SIB 34 07 24

RECALL 24V-739: INTEGRATED BRAKE SYSTEM (IB)

This Service Information Bulletin (Revision 4) replaces SI B34 07 24 **dated March 2025**.

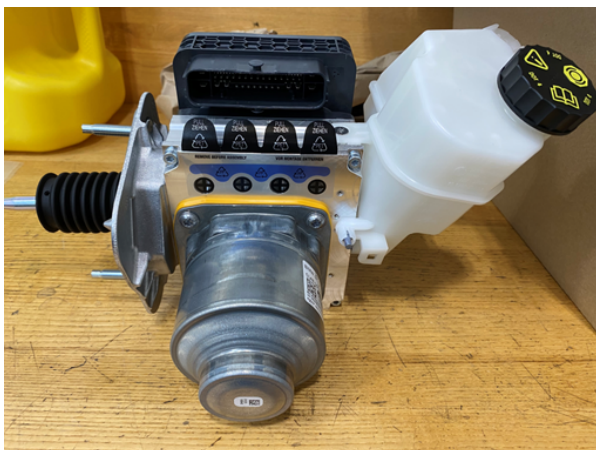
Replace the IB with either a “wet” pre-filled unit or a “dry” unfilled unit.

“Wet” IB pre-filled: Brake fluid reservoir is filled (arrow) and brake fluid line ports are plugged with bolts (circled).

“Dry” IB unfilled: Brake fluid reservoir is empty; brake fluid line ports are sealed with labels.

5B67B85
5B69D65
5B6E463
5B6E467
5B69D61
5B69D63
5B6F947
5B72715
5B72716
5B6F943

5B3C874
5B3C857
5B421D0
5B3C859
5B6C7F1
5B6C7F2
5B6C7F3
5B6C7F5

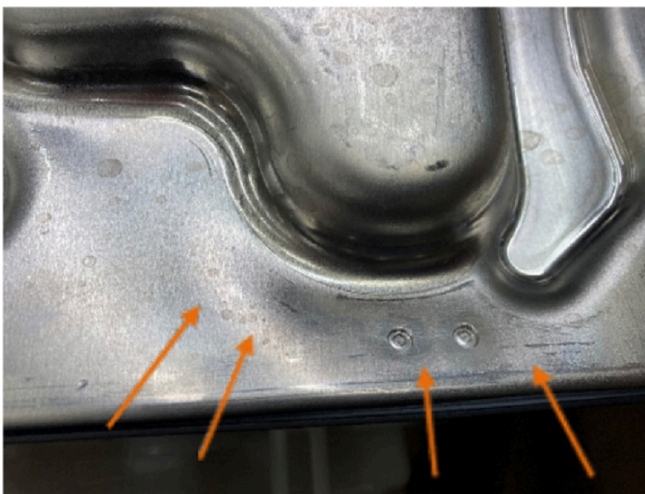
Do not install any part which shows visual damage as shown in these 2 photos, or has been dropped from any height.
